4405 EAST WEST HIGHWAY SKETCH PLAN NO. 320220120

No. 320220120

Completed: 10-24-2022

MCPB

Figure 3 – Sketch Plan

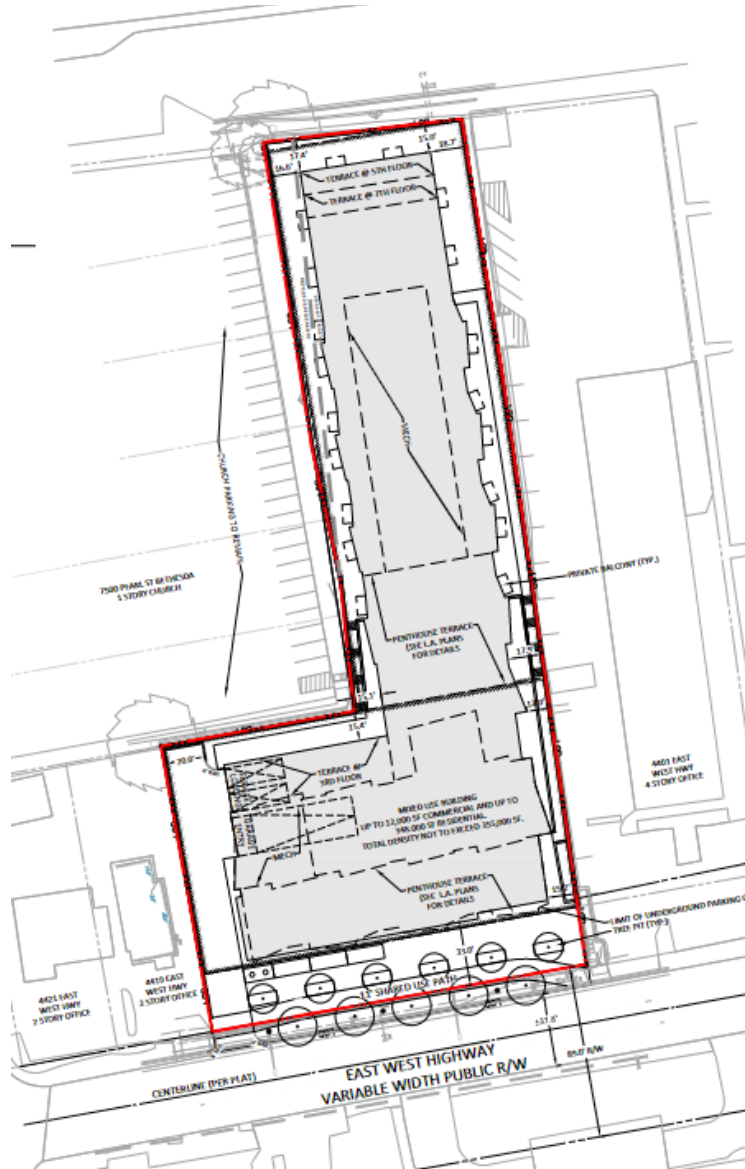
- **Access Location:** As discussed in Section 4, all vehicular access will be provided by a consolidated driveway on East-West Highway, with a final alignment to be determined at the time of Preliminary Plan; subject to MDOT SHA approval. Furthermore, in their October 5, 2022 letter, MDOT SHA indicated the driveway location as shown on the Sketch Plan will need to be relocated.

- **Noise and Screening:** The proposed development will be evaluated for conformance with applicable noise and screening requirements at the time of Preliminary and Site Plan reviews. Relocation of the access point further to the east in these future applications will itself help to mitigate noise and screening concerns raised.

- **Building Massing:** Further conformance with building and architectural design requirements will be evaluated at the time of Site Plan review. As a change in location of the access point to

the proposed building is expected in future applications in response to MCDOT SHA's October 5, 2022 recommendation, changes to the building design are anticipated.

- a. The final design, alignment and dimensions of the single vehicular access point will be determined at the time of Preliminary Plan, subject to MDOT SHA approval.

- b. The sidepath will be required to provide an ADA accessible transition between the Site and the adjacent properties to the east and west. The final design of the sidepath will be determined at the time of Site Plan.
